## **QUESTIONS AND ANSWERS RELATED TO THIS PROJECT**

### **CONSTRUCTION SERVICES FOR FREEDOM FIELD REHABILITATION TOWN OF HUDSON, NEW HAMPSHIRE**

Existing Conditions Plan  
**Town of Hudson - Freedom Field**  
 194 Derry Road  
 Hudson, NH  
 Assessors Map 138 Lot 89

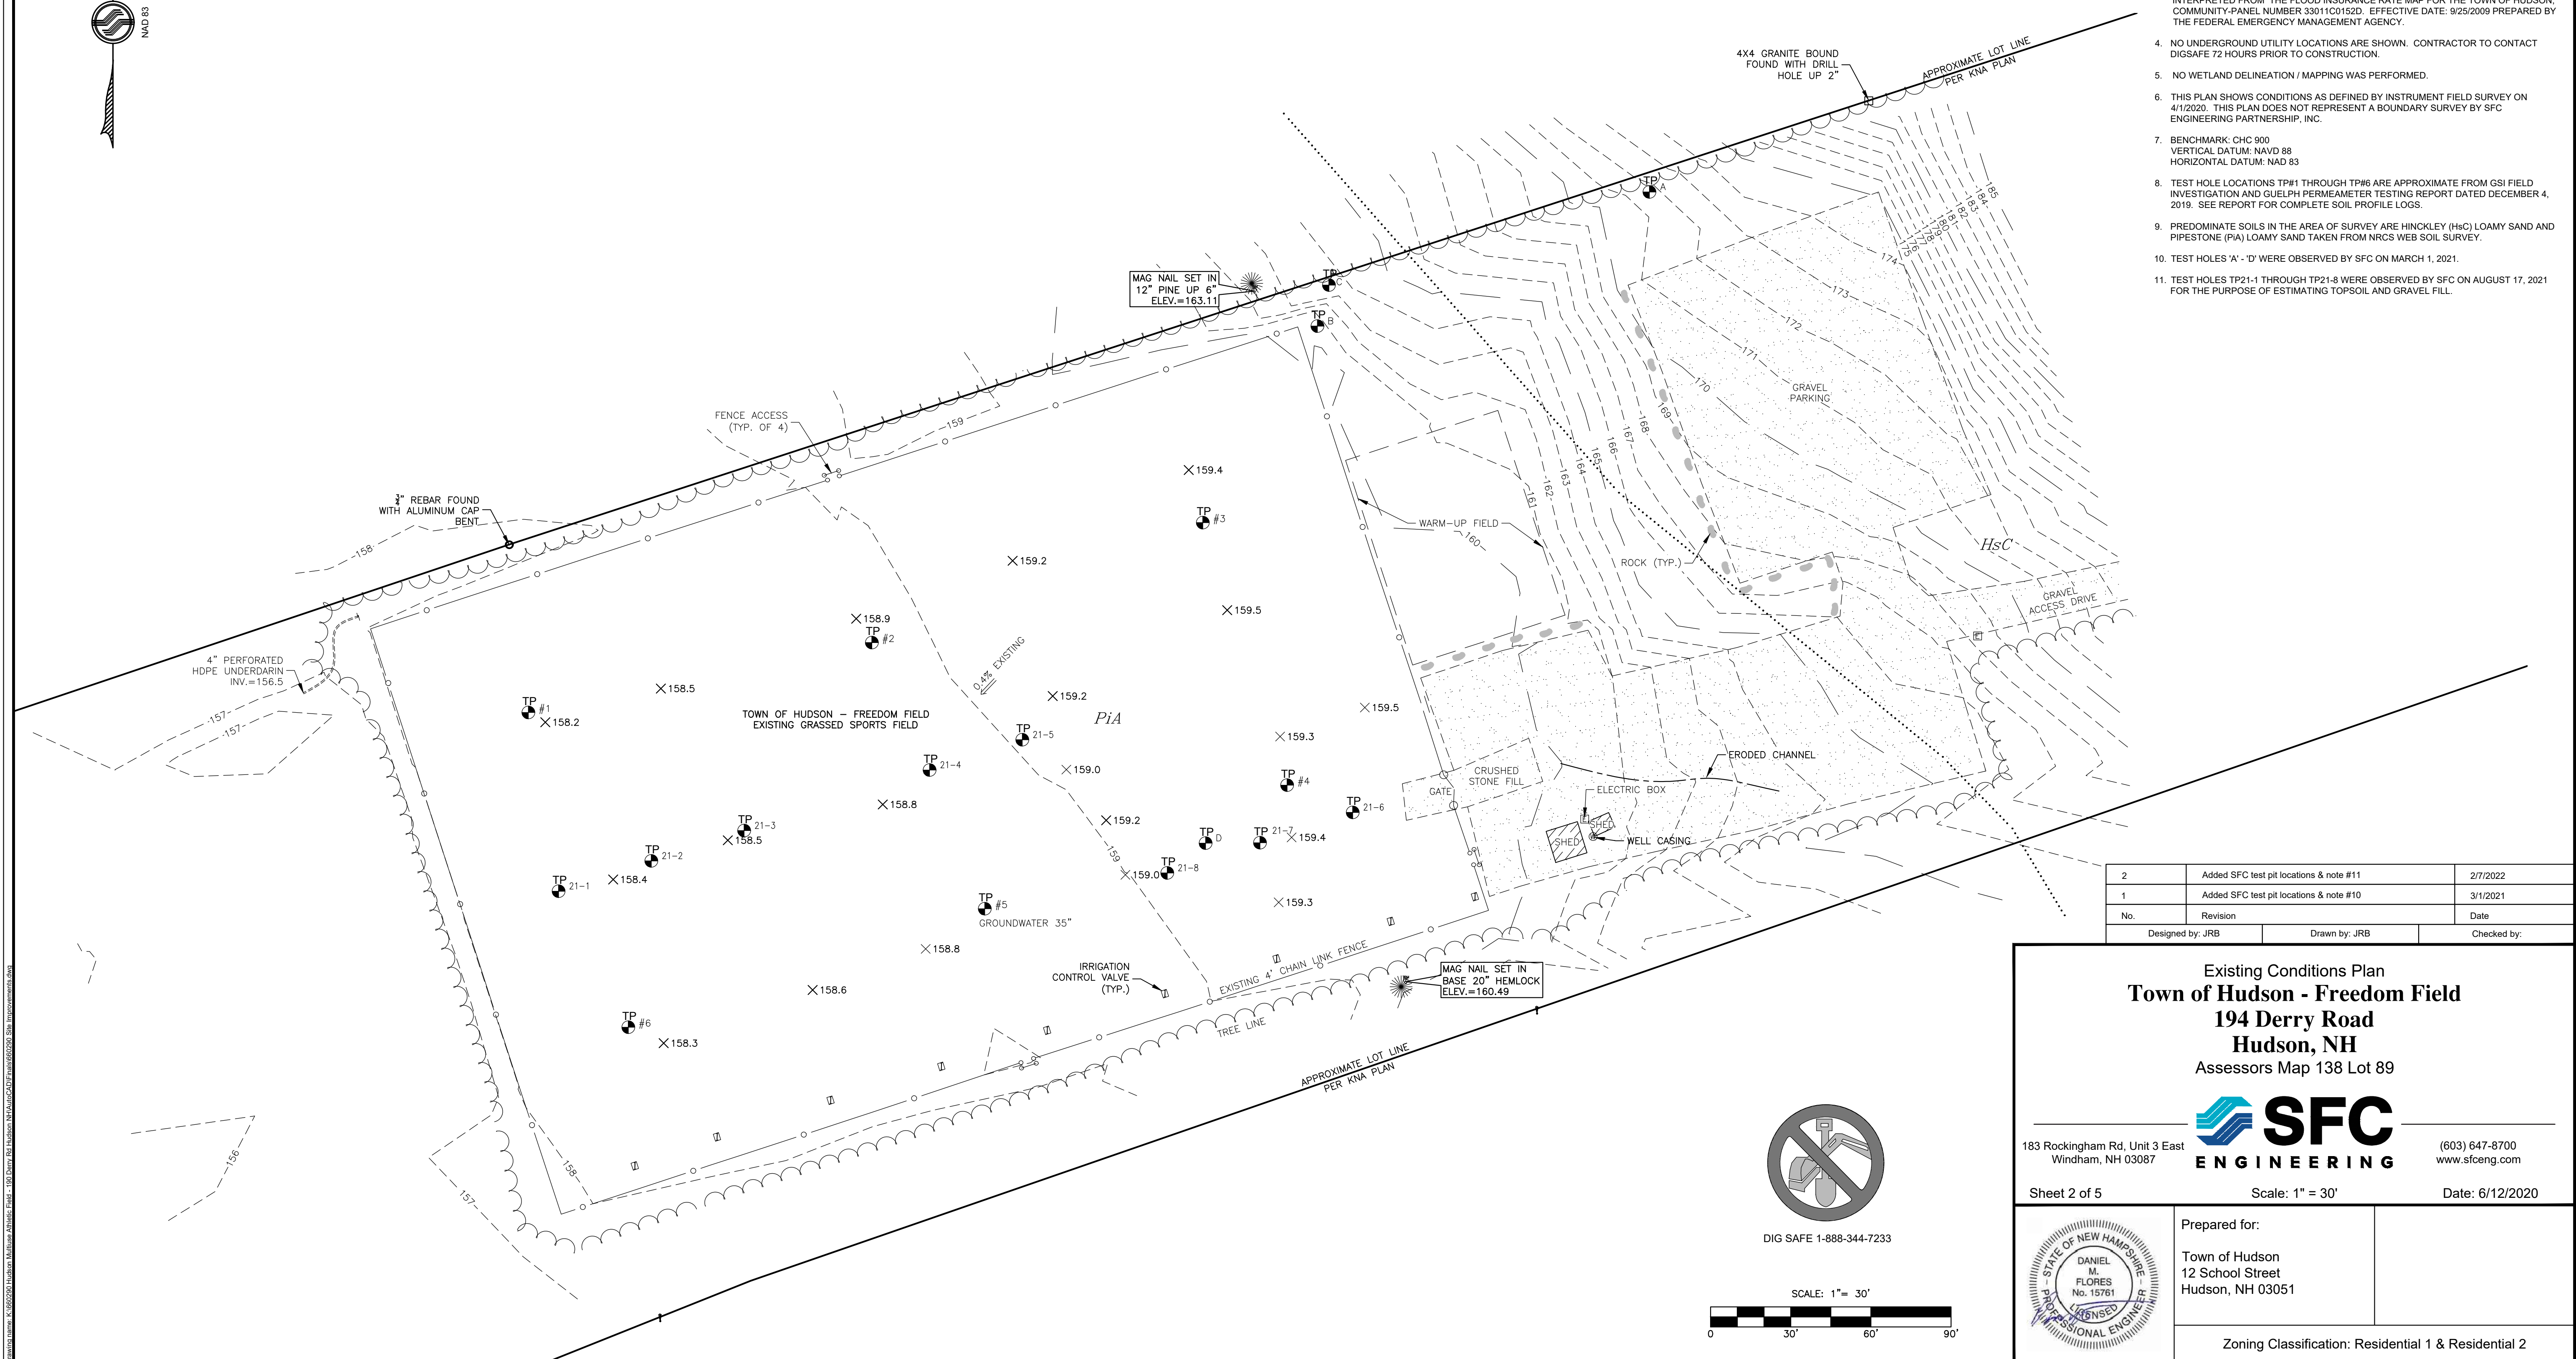
Question 6: Could you provide test pit information?

Answer 6: Soil testing information has been provided.
